Report No.: SIR-05-044-A
Revision No.: 0
Project No.: GE-10Q
File No.: GE-10Q-401
April 2007

Pressure-Temperature Limits Report
Methodology for Boiling Water Reactors

SUBJECT: FINAL SAFETY EVALUATION FOR THE BOILING WATER REACTOR OWNERS' GROUP (BWROG) STRUCTURAL INTEGRITY ASSOCIATES TOPICAL REPORT (TR) SIR-05-044, "PRESSURE TEMPERATURE REPORT METHODOLOGY FOR BOILING WATER REACTORS" (TAC NO. MC9694)

APPENDIX C: NRC REQUEST FOR ADDITIONAL INFORMATION (RAI) AND BWROG RESPONSE TO RAI C-1

Figure 2-7: Nozzle Thickness Definition

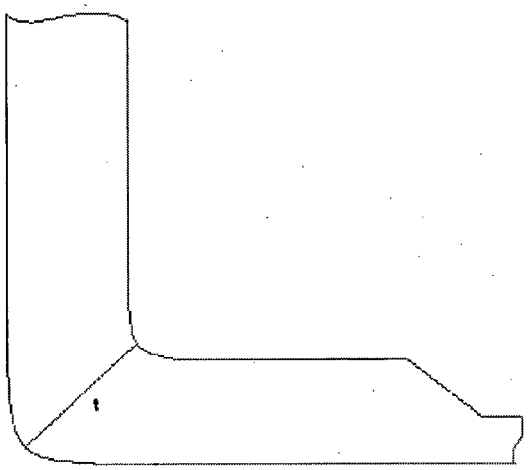
The non-beltline region analysis method that was contained in Section 2.5 has been deleted and replaced with a methodology that is described in the BWROG response to RAI No. 3. In this methodology the location to be analyzed for determining the highest stresses in the non-beltline region is the feedwater nozzle. The reference temperature, RT_{NDT}, used in the analysis is the limiting value for all non-beltline nozzles. The stress intensity factors for the feedwater nozzle may be calculated from a detailed finite element model analysis of the nozzle. The stress distribution from the finite element analysis is fit with a third order polynomial. The stress intensity factors for the nozzle corner use the coefficients from the stress distribution polynomial and a method proposed in General Electric (GE) Topical Report NEDE-21821-02 (Reference 14) for calculating stress intensity factors for nozzle corner cracks. The stress intensity factor solutions documented in Reference 14 were verified by independent analysis and experiment. Reference 14 was approved by the NRC staff in a letter from D. G. Eisenhut (NRC) to R. Gridley (GE) dated January 14, 1980 (ADAMS Legacy Library Accession No. 8002070141). The NRC staff concluded that each step in the GE analysis is acceptable, but had specific comments. Since none of the comments were directed at the stress intensity solutions for the nozzle corner crack, the stress intensity solutions proposed were considered acceptable for evaluating nozzle corner cracks. The proposed methodology uses the stress intensity factors from both thermal and pressure stress to develop P/T limits based on the structural factors described in Appendix G to Section XI of the ASME Code. The NRC staff finds the non-beltline methodology acceptable since it meets the requirements of ASME Code, Section XI, Appendix G and the stress intensity factors are determined using a previously approved methodology. However, the NRC staff requires that the information provided in response to RAI No. 3 be incorporated into the -A version of the LTR.

Section 2.5 of the LTR and the methodology proposed in response to RAI No. 3 to describe methodologies for calculating bending and membrane stresses using computer code finite element analyses. If these finite element analyses are to be utilized by licensees to develop P/T limits, the NRC staff requested, in RAI No. 2, that the BWROG provide the following:

For a path through the limiting nozzle inner blend radius corner, as shown in Figure 2-7, the thermal and pressure hoop stress distributions should be extracted from the finite element model. Each of the stress distributions should be fit with a third-order polynomial that reasonably fits the calculated stresses in the region of interest.

The figures below will be added as new Figures 2-7 and 2-8 of the TR.
